LSD Ebersole Center Food Service Bid Pack 2, Addendum No. 1

Narrative of Changes

Project Name:	Ebersole Center Food Service – Equipment Replacement & Renovations SO-1853	Date:	April 3, 2026
Project Location:	3400 2 nd St Wayland, MI 49348	Architect's Project #:	26000750A
Owner/Client:	Lansing School District	Attention:	David Beckering
Issued to:	Beckering Construction	Email:	djb@beckering.com
City/State:	Grand Rapids, MI	Zip:	49548

DRAWING NUMBER:
A101

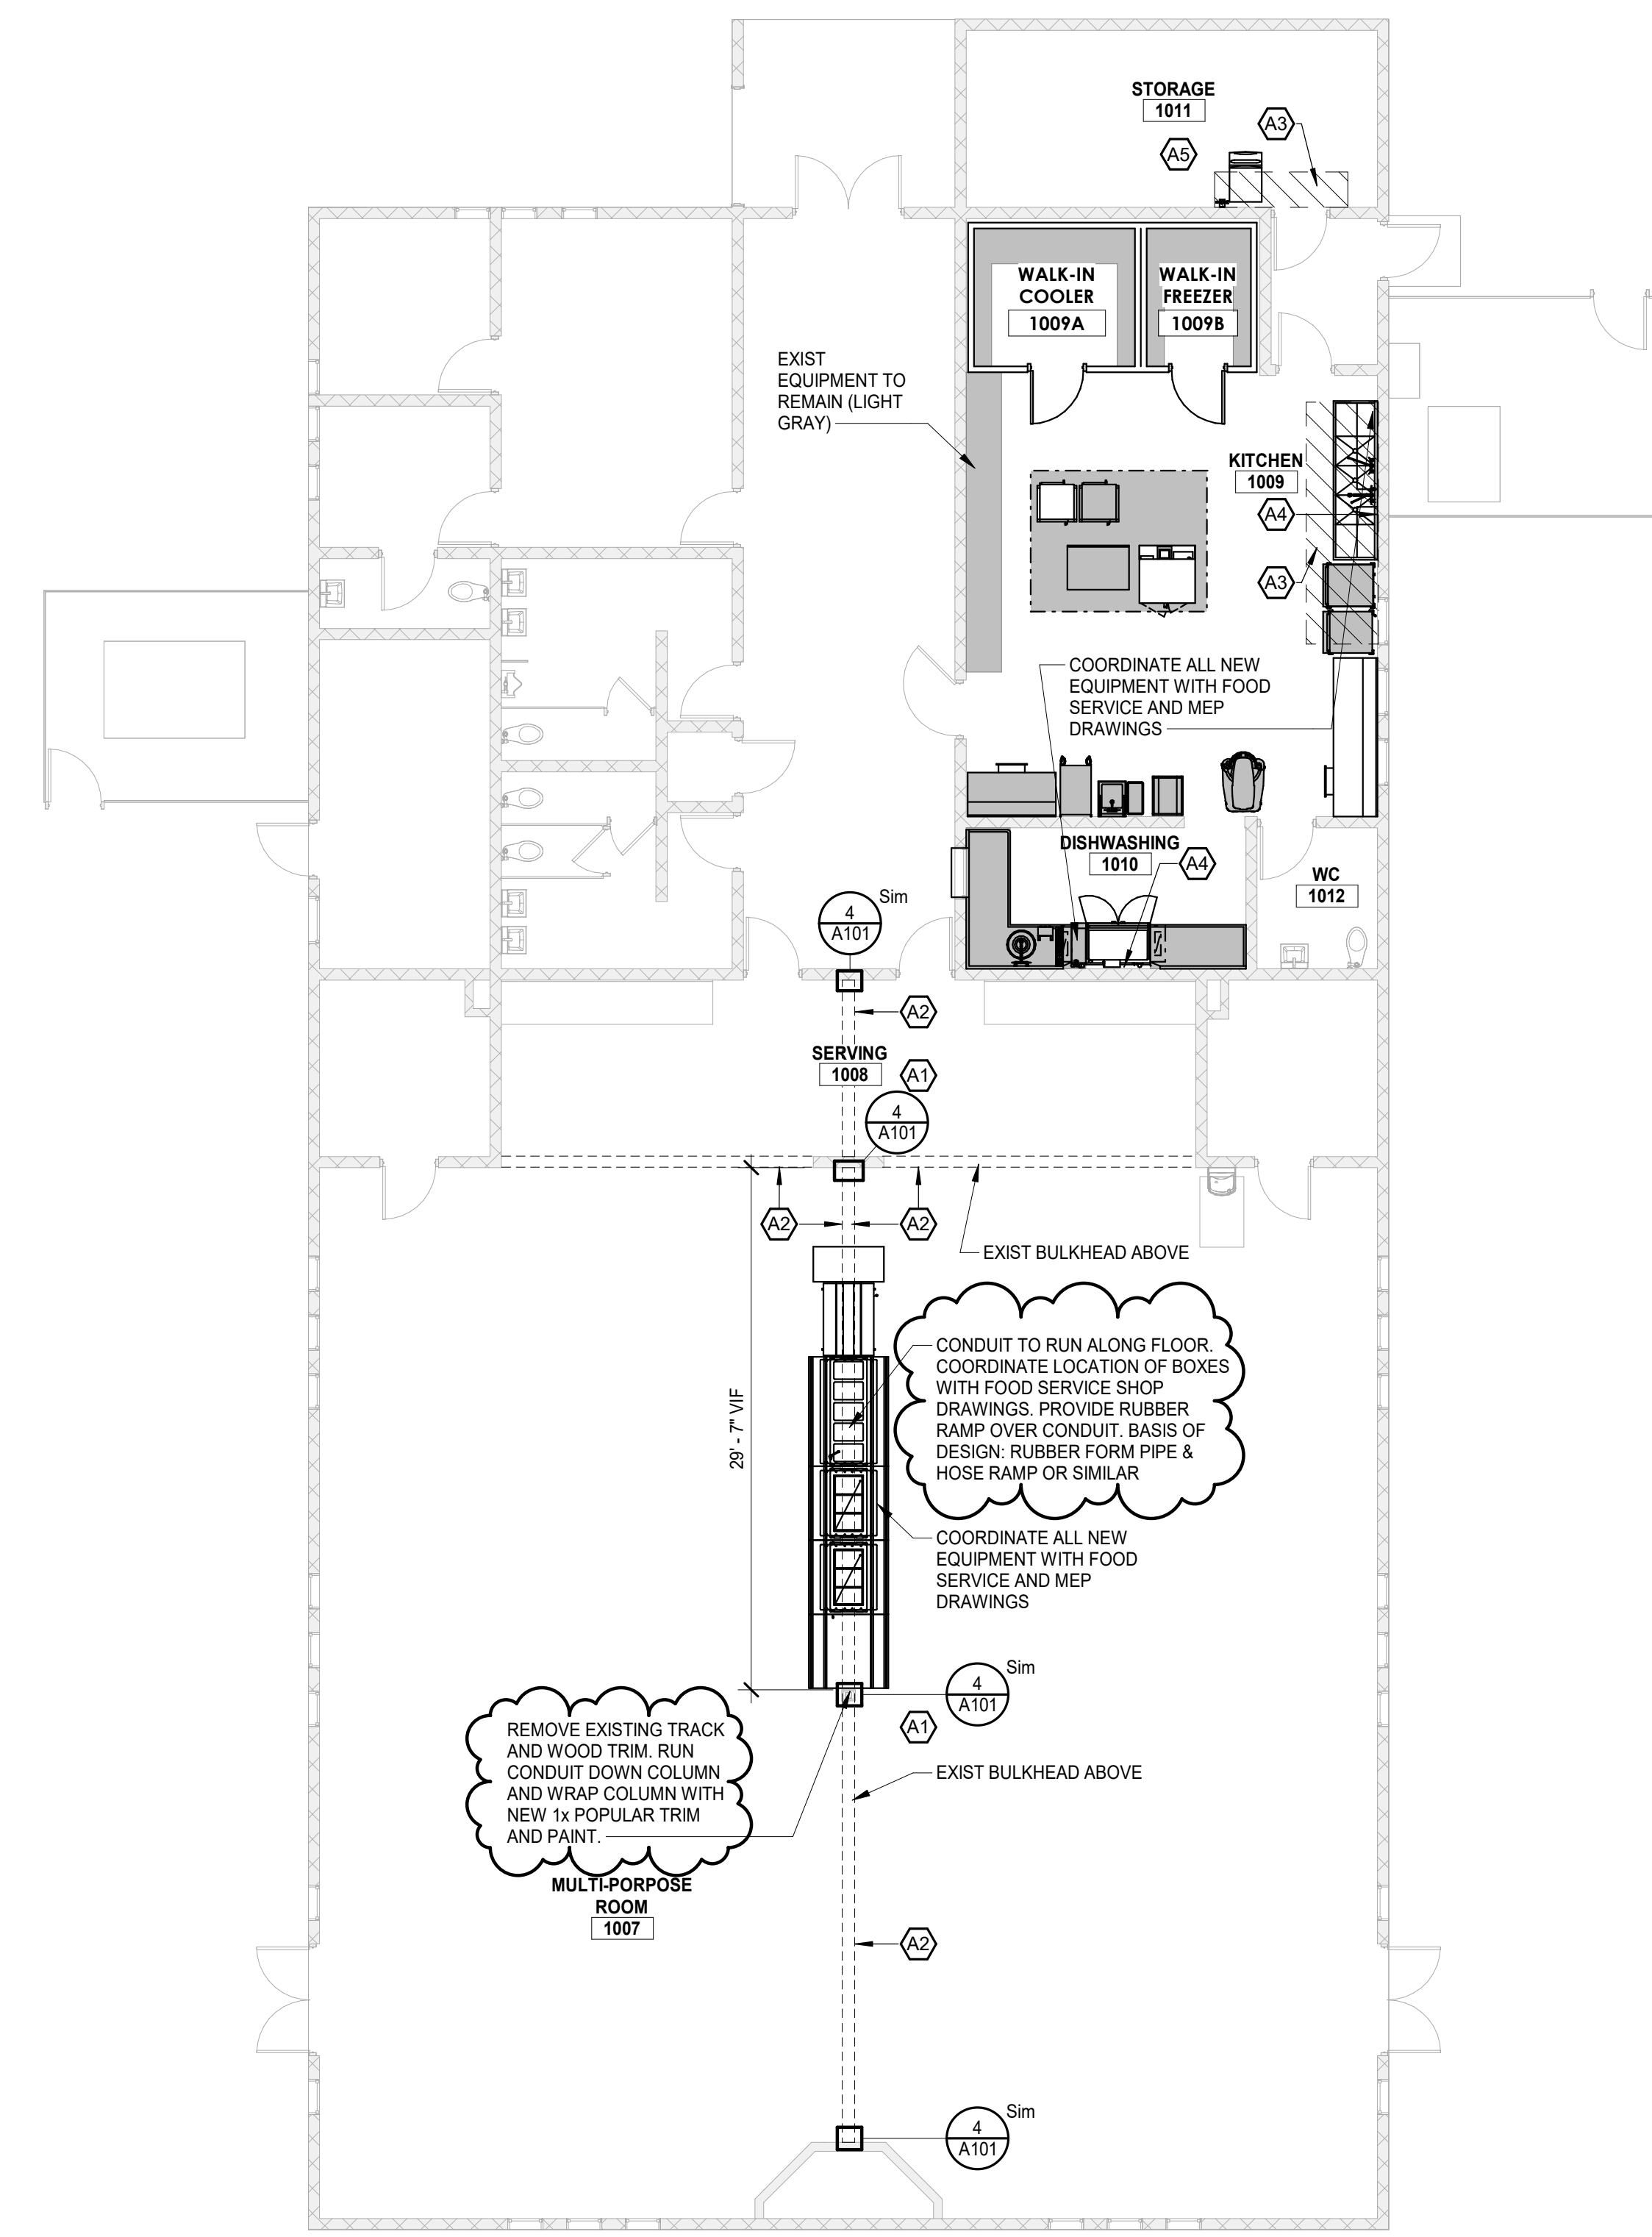
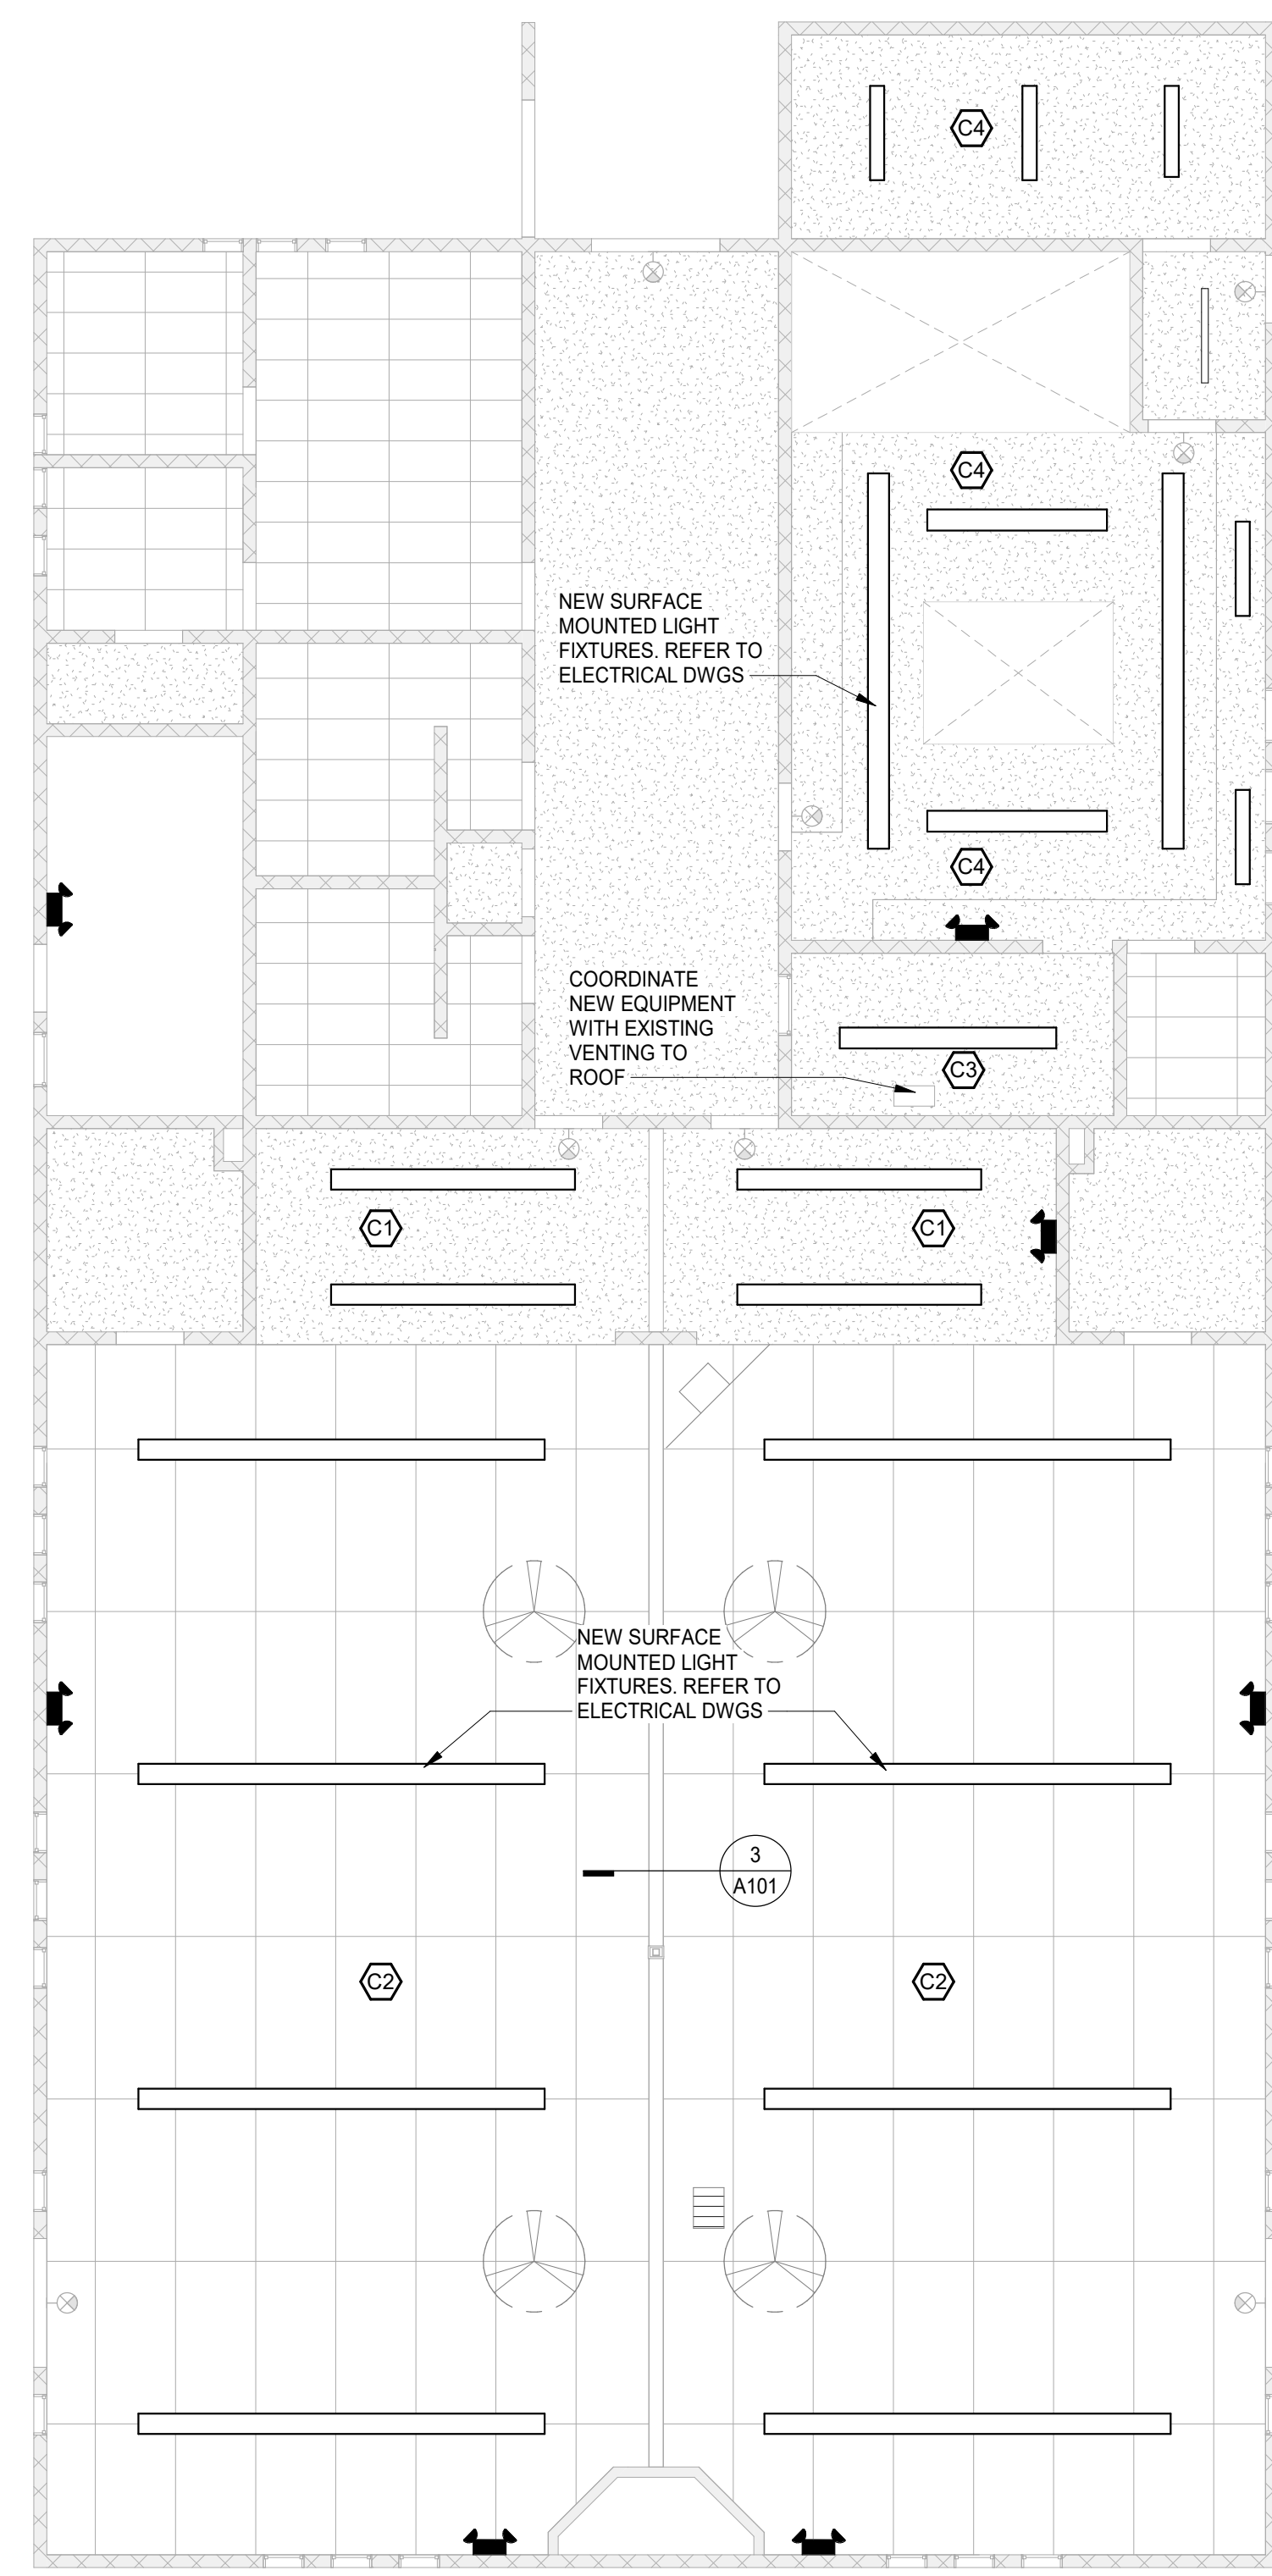
- A101 – FIRST FLOOR AND CEILING PLANS (Reissued)
 - Added paint specifications.
 - Revised note regarding column wrap and conduit running inside of column wrap and across the floor.
 - Revised note regarding painting of trim

E100

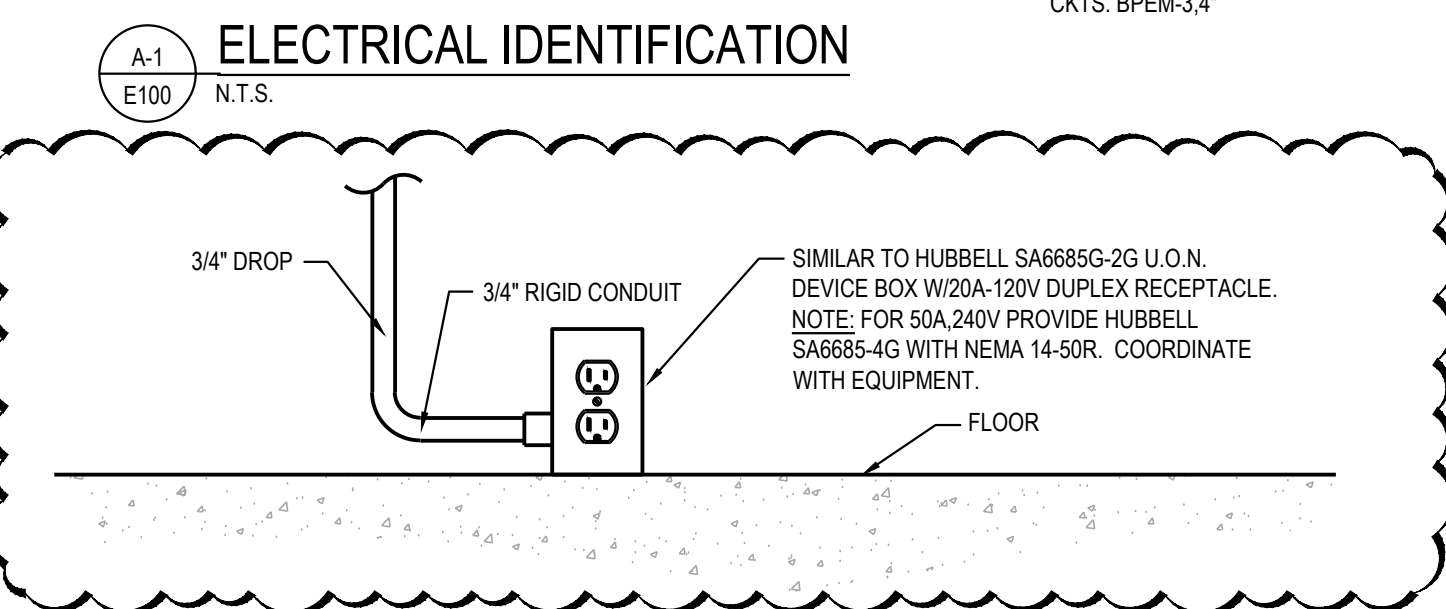
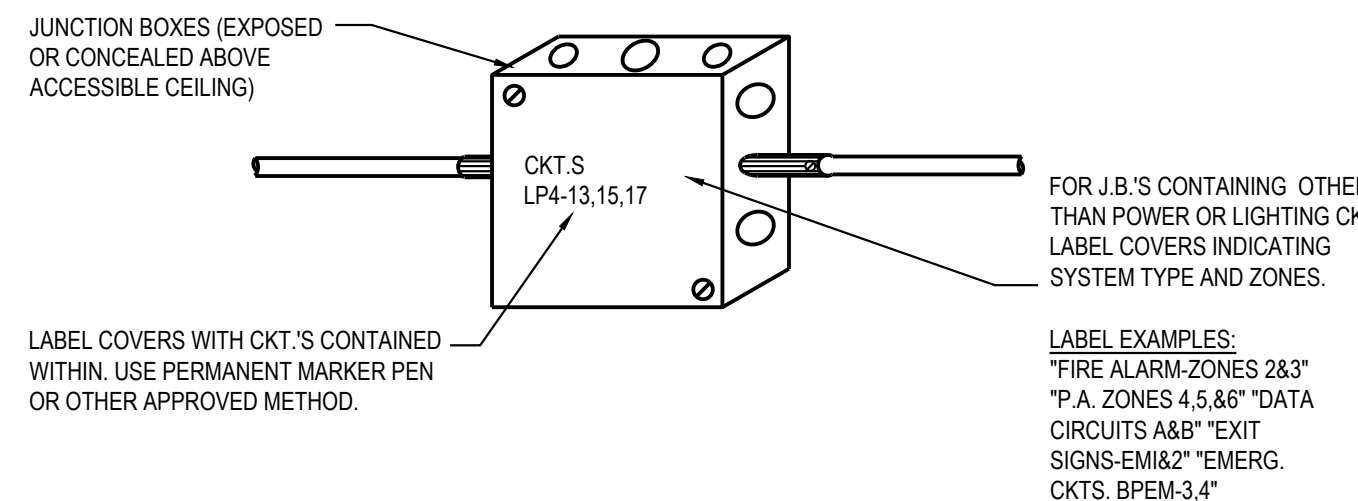
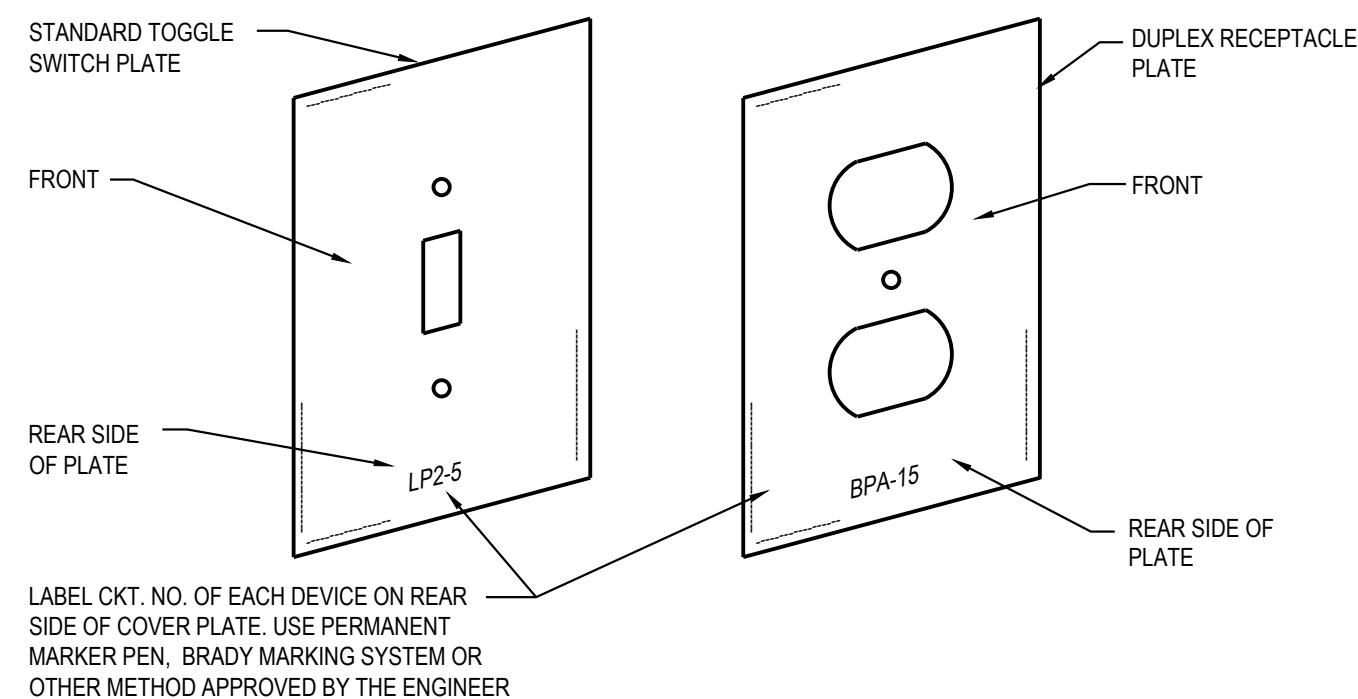
- E100 – DETAILS, SYMBOL LEGENDS & SPECIFICATIONS
 - Added new type b in fixture schedule
 - Added Columbia manufacturer to the schedule as approved
 - Allow watt stopper as approved equal for lighting controls
